**SUBJECT:** NuScale Power, LLC Response to NRC Request for Additional Information No. 9306 (eRAI No. 9306) on the NuScale Topical Report, "Rod Ejection Accident Methodology," TR-0716-50350, Revision 0

## **Response to Request for Additional Information Docket No. 52-048**

**eRAI No.:** 9306

Figure 5-1 Control rod assembly layout for the NuScale Power Module

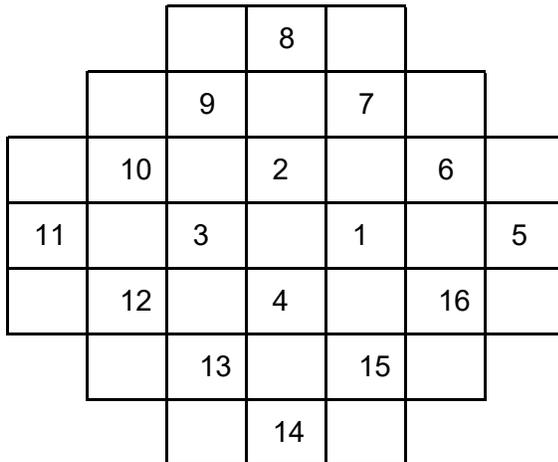
- a. Please indicate if the uncertainties in Table 5-1 will be updated consistent with TR-0616-48793. If the uncertainties will not be updated as discussed in TR-0616-48793, either describe the method for updating them or provide a justification as to why an update is not necessary. If the uncertainties in Table 5-1 will be updated, modify TR-0716-50350 to indicate the method by which updates will be made.
  - b. Justify the use of a lower  $F_{\Delta H}$  uncertainty for the rod ejection analysis relative to the steady-state  $F_{\Delta H}$  uncertainty.
-

- a. The uncertainties in Table 5-1 are updated as described in TR-0616-48793 (Reference 8.2.7) for all except the  $F_{\Delta H}$  engineering uncertainty, which is updated consistent with the value in the Subchannel Analysis Methodology topical report (TR-0915-17564, Reference 8.2.11). The Rod Ejection Accident Methodology topical report (TR-0716-50350) was revised as indicated in the markup provided with this response to define the method in which the update is made. The title of Table 5-1 was also revised to
-

The core is designed with quadrant symmetry, where CRAs 1, 5, 15, and 16 in Figure 5-1 represent all unique CRA positions in the core. Only the CRAs in the regulating bank are eligible for ejection and considered in the REA methodology.
